**YESLER TERRACE
BLOCK 5 | BLDG A**

EAST DESIGN REVIEW BOARD

DESIGN RECOMMENDATION MEETING

209 12TH AVE S | PROJECT #3026743

1 DEPARTURE
RETAIL SECTION @ 12TH AVE

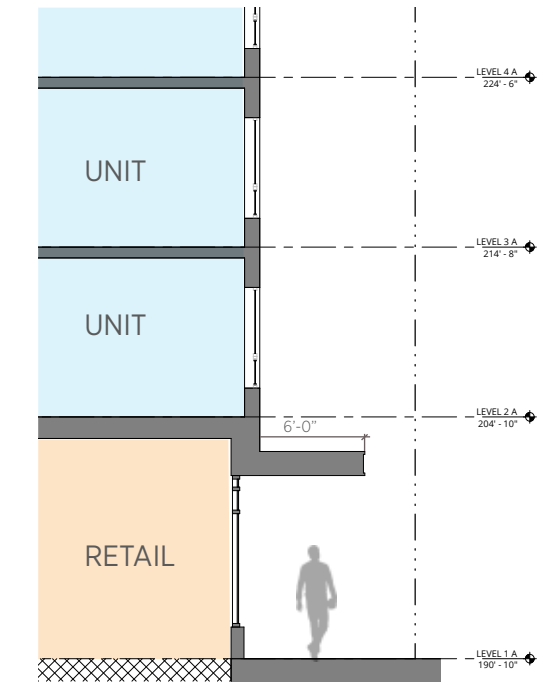
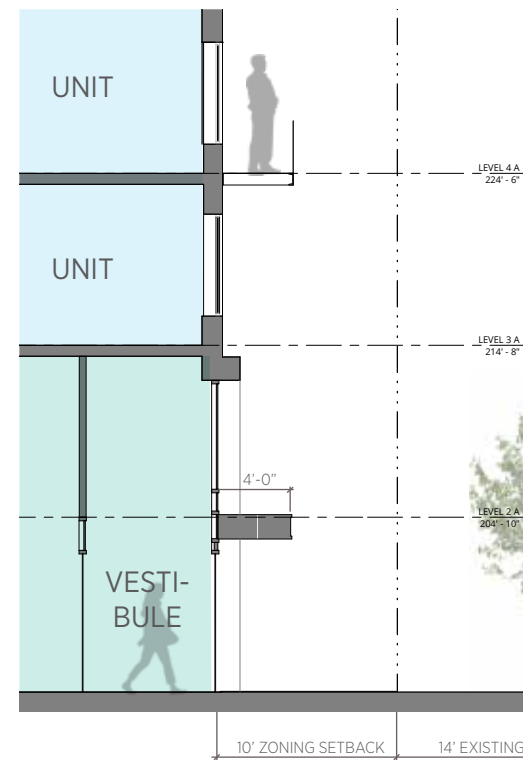
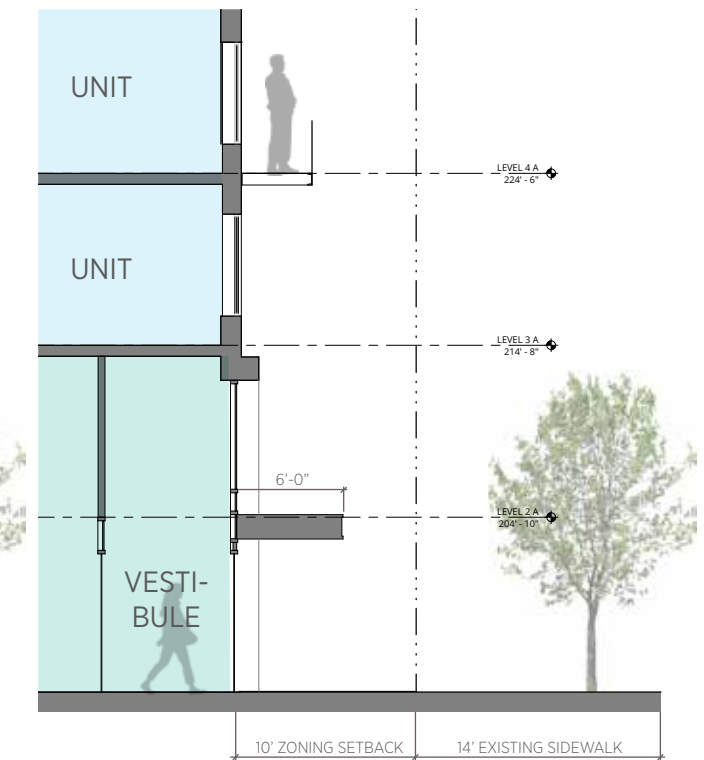
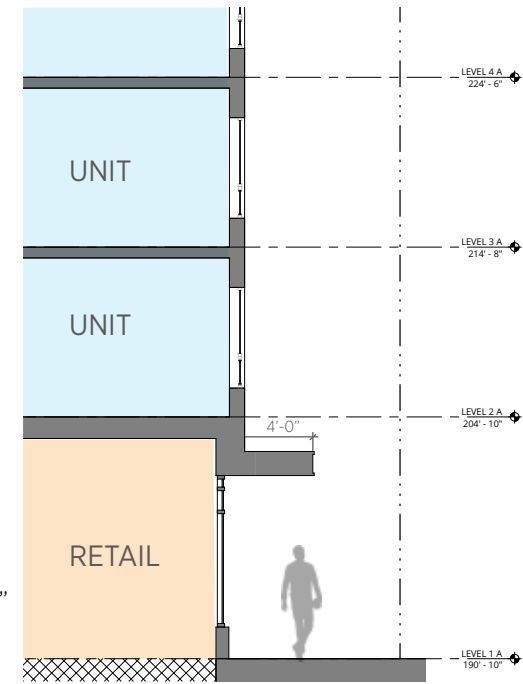
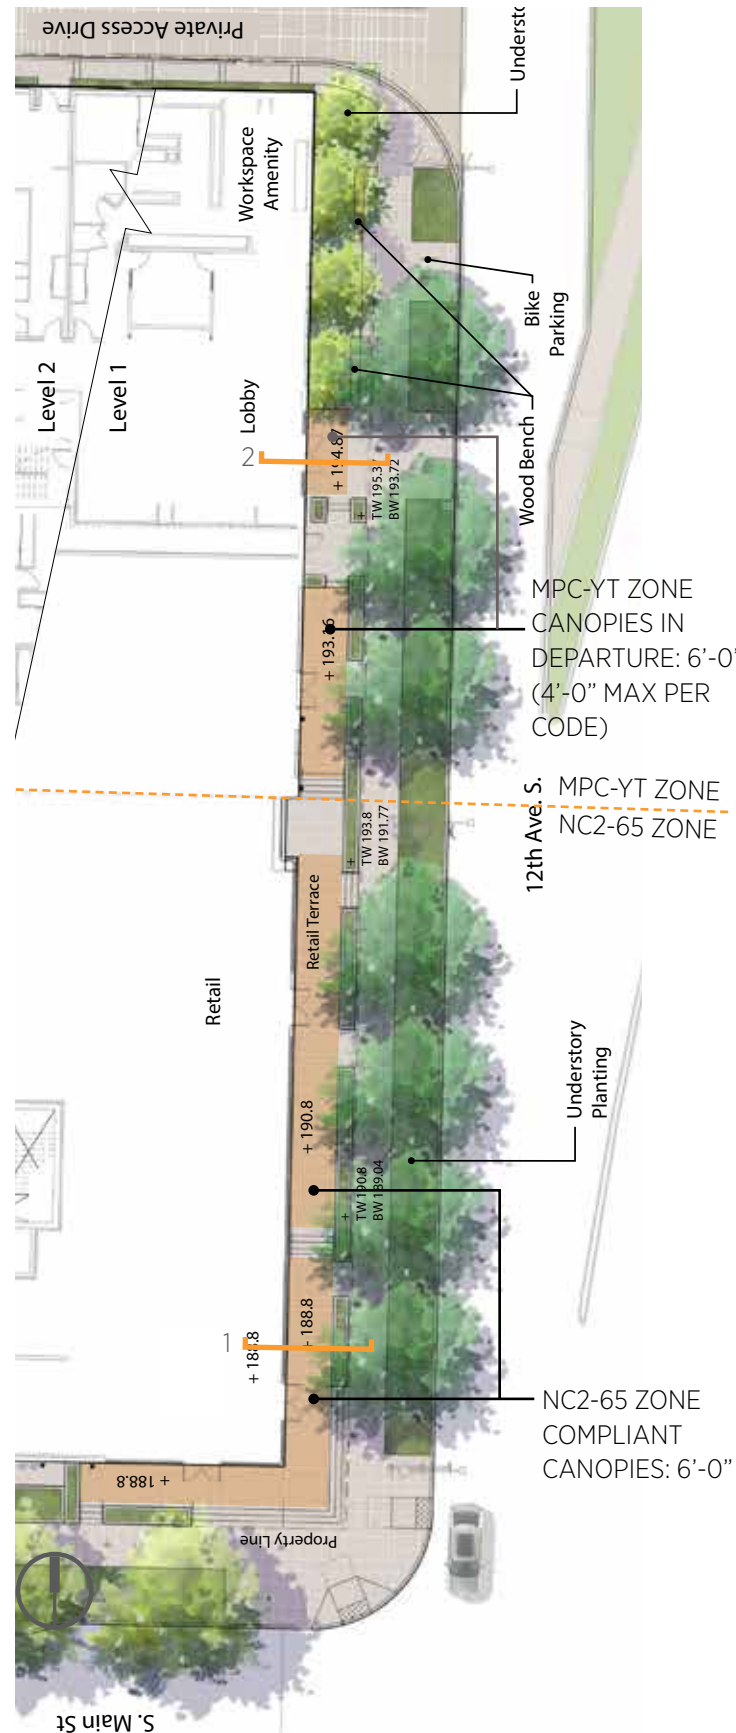
Provide canopies above the residential lobby and retail entries along the 12th ave facade and wrapping the corner at Main St, extending 6 feet beyond the facade into the required setback.

The extended canopy adds depth to the facade, creates visual interest and a nice human scale at the street level. This also allows for the canopies along 12th to have a consistent depth with the NC2-65 zone at the corner of Main and 12th. This will provide a better pedestrian experience and help activate the street level uses.
